Item Name: Aft Crosstube - High

## RETURN AUTHORIZATION

DRAWING NO. D212-664-241	TITLE CROSSTUBE ASSY (205/212 HI AFT)	REV. D	DART AEROSPACE LTD ENGINEERING ORDER		D.E.O. NO. D212-664-241-D-1	SHEET NO. SHEET 1 OF 2	SCALE NTS
DRAWN	CHECKED	MFG. APPR.	APPROVED	DE APPR.			
DATE 11.04.07	DATE 11.04.11	DATE 11.04.12	DATE 11/04/12	DATE 11.04.12

DRAWING NO. D212-664-241	TITLE CROSSTUBE ASS'Y (205/212 HI AFT)	REV. D	<b>DART AEROSPACE LTD ENGINEERING ORDER</b>		D.E.O. NO. D212-664-241-D-2	SHEET NO. SHEET 1 OF 1	SCALE NTS
DRAWN <i>Q</i>	CHECKED <i>ASS</i>	MFG. APPR. <i>B</i>	APPROVED <i>MD</i>		DE APPR. <i>#</i>		
DATE 11.07.15	DATE 11.07.20	DATE 11.07.21	DATE 11/27/21		DATE 11-07-21

**D212-664-241/-241B  
ASSEMBLY DETAIL**

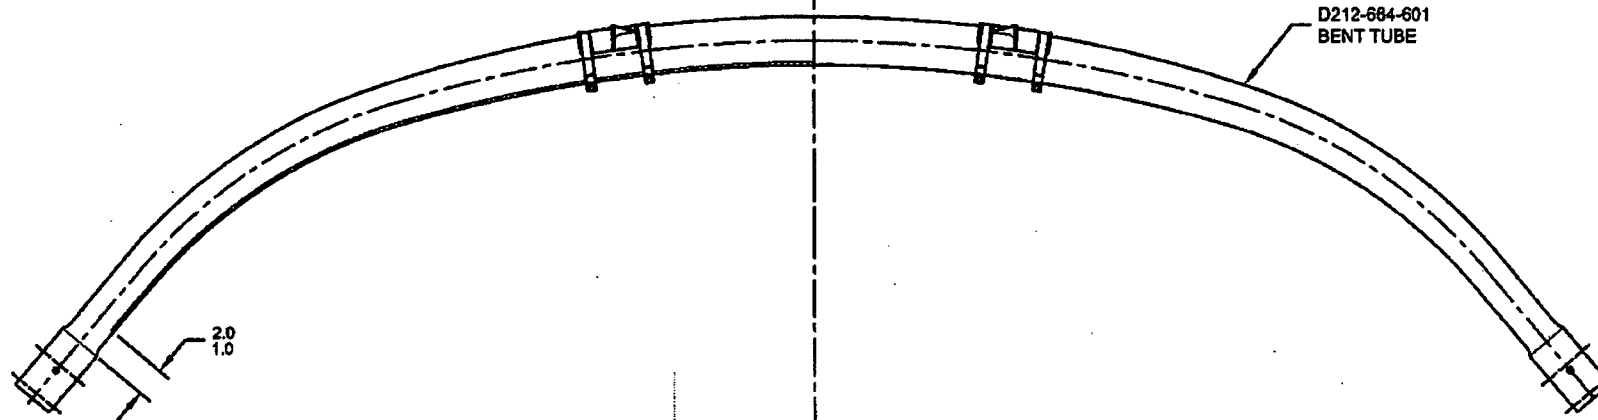
**PURPOSE:**

ADD AN INSPECTION WINDOW TO UNDERSIDE OF CROSSTUBE.

NOTES 2 OF SHEET 1 IS AMENDED AS FOLLOWS:

- 2) FINISH: CHEMICAL CONVERSION COAT PER DART QSI 005 4.1  
PRIME INSIDE AND OUTSIDE PER DART QSI 005 4.2  
MASK UNDERSIDE OF CROSSTUBE AS SHOWN (HATCHED AREA) AND  
PAINT OUTSIDE PER DART QSI 005 4.2  
REMOVE MASKING AND APPLY CLEAR COAT

MASK AREA PRIOR TO PAINTING,  
REMOVE MASKING AFTER PAINT  
AND APPLY CLEAR COAT
